## **CEDAR & SAINT SUBDIVISION**

Engineering Comments: FINAL PLAT COMMENTS (should be addressed prior to submitting the FINAL PLAT for review and/or signature by the City Engineer):

APPLICATION NUMBER 5 DATE December 5, 2019

APPLICANT Cedar & Saint Subdivision

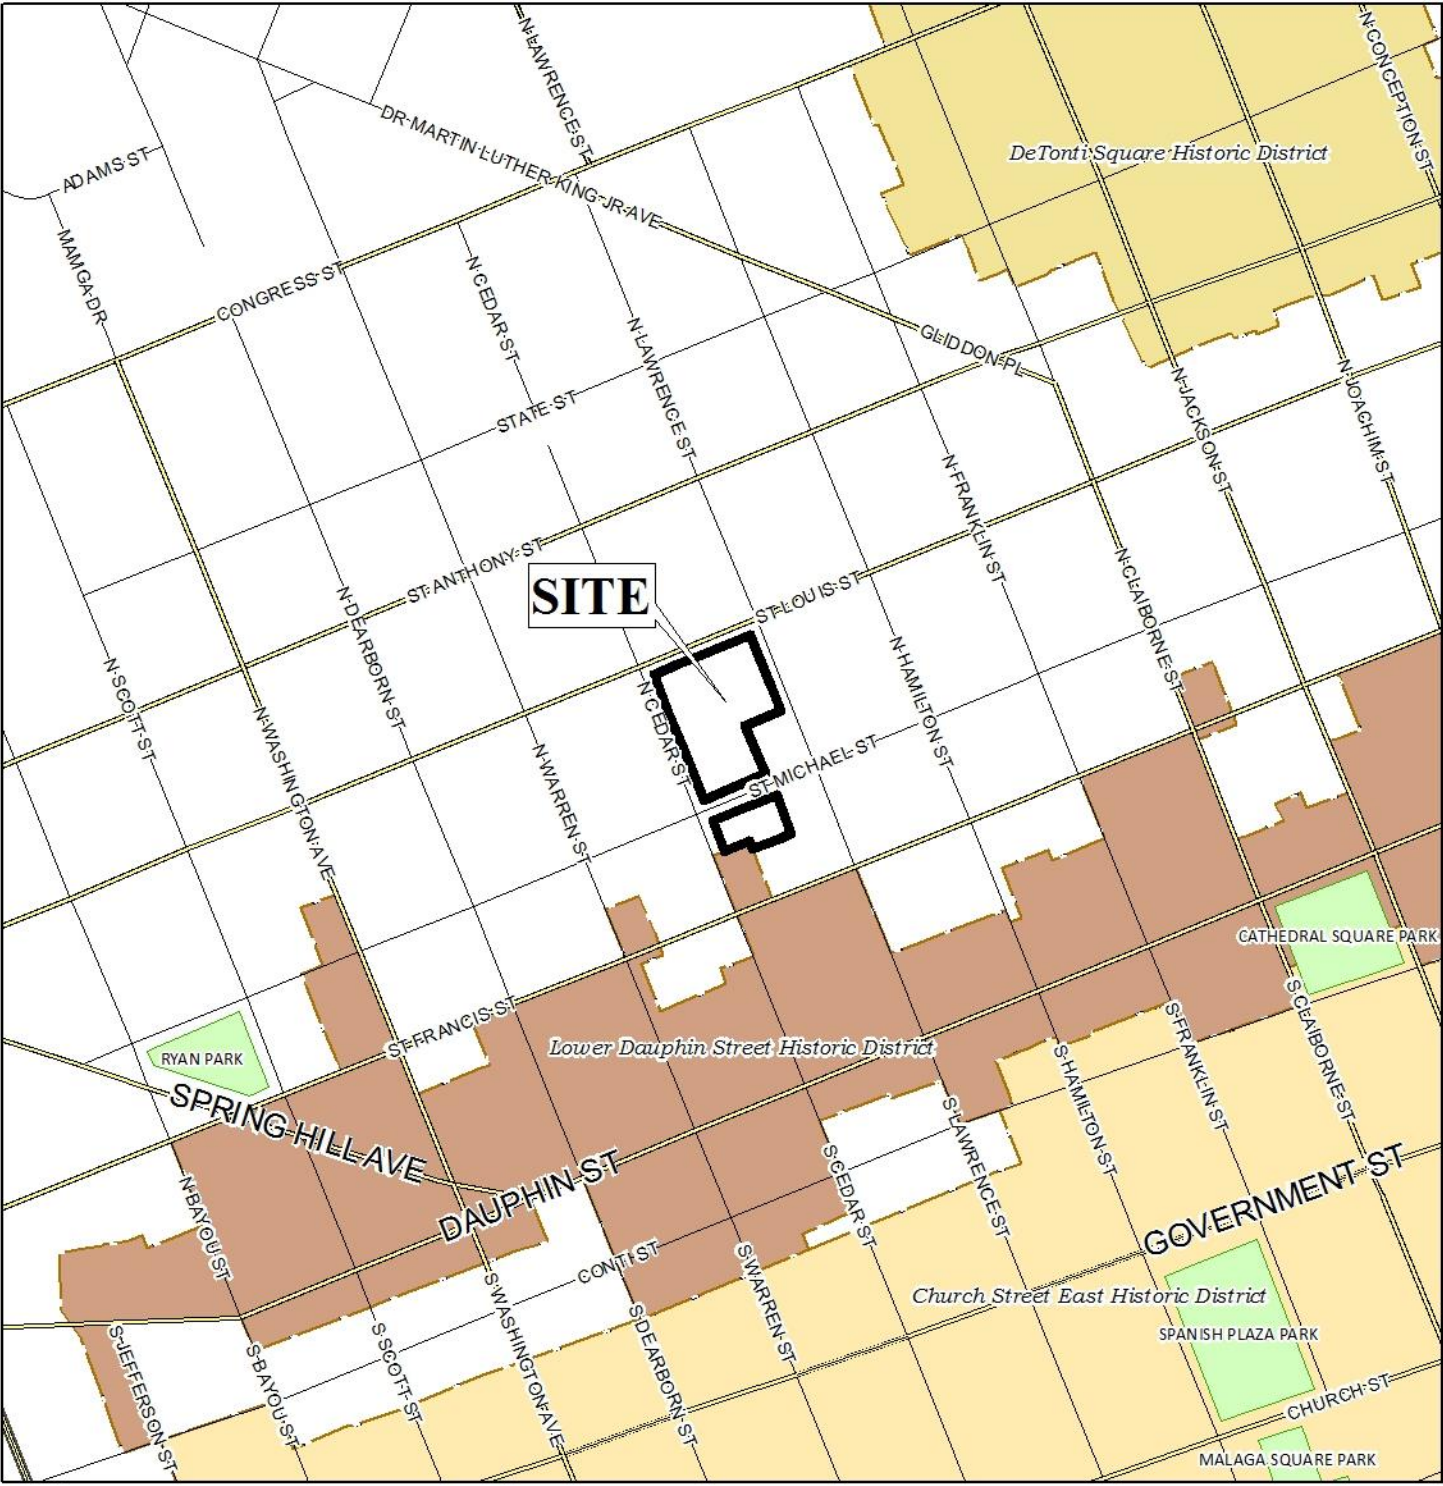
The plat illustrates the proposed 2-lot, 1.6 ± acre subdivision which is located on the Southwest corner of Saint Louis Street, and North Cedar Street, extending to the Southeast corner of Saint Louis Street and North Warren Street, and the Northeast corner of North Warren Street and Saint Michael Street, and Southeast corner of Saint Michael Street and North Warren Street, within Council District 2. The applicant states that the subdivision is served by city water and sanitary sewer systems. The purpose of this application is to create two (2) legal lots of record from eight (8) metes-and-bounds parcels.

The proposed Tract 1 has frontage along Saint Louis Street, North Lawrence Street, Saint Michael Street, and North Cedar Street while Tract 2 fronts only Saint Michael Street and North Cedar Street all of which are minor streets with curb and gutter. As a minor street, a 50' right-of-way width is typically required per the Subdivision Regulations. Both Saint Louis and Saint Michael Streets are illustrated as compliant on the proposed plat and, if approved, should be retained on the Final Plat. The preliminary plat illustrates a right-of-way width of 40 feet for both North Cedar Street and North Lawrence Street. However, it appears that the existing right-of-way for both streets is approximately 50 feet therefore, if approved; the Final Plat should be amended to reflect the correct rights-of-way width for both.

The preliminary plat does not depict setbacks. If approved, the Final Plat should be amended to reflect the minimum and maximum setbacks allowed for each lot based upon its respective Sub-district. Also, the lot size information in square feet and acres should be retained on the Final Plat, if approved

Finally, the plat should be revised so that “Tract 1” is renamed “Lot 1,” and “Tract 2” is renamed “Lot 2.”

- 1) Revision of the plat to rename “Tract 1” to “Lot 1,” and “Tract 2” to “Lot 2;”
- 2) Submission of an application to the Board of Zoning Adjustment to request a variance from Section 64-3.I.11.(c)(1) of the Zoning Ordinance to allow parking access from Saint Louis Street, if applicable, prior to the signing of the Final Plat;
- 3) Depiction of the building setbacks for Lot 1 to be a minimum of 0 feet and a maximum of 10 feet along the Saint Louis Street frontage, and subject to fire rating requirements for all other frontages;

- 4) Depiction of the building setbacks for Lot 2 to be a minimum of 0 feet and a maximum of 12 feet, or to match setbacks of adjacent buildings (along the same street frontage) where they differ from the standard;

- 5) Retention of the lot size labels in both square feet and acres on the Final Plat or the furnishing of a table on the Final Plat providing the same information;

- 6) Revision of the rights-of-way widths on the Final Plat for both North Cedar Street and North Lawrence Street to reflect the existing right-of-way of 50 feet;
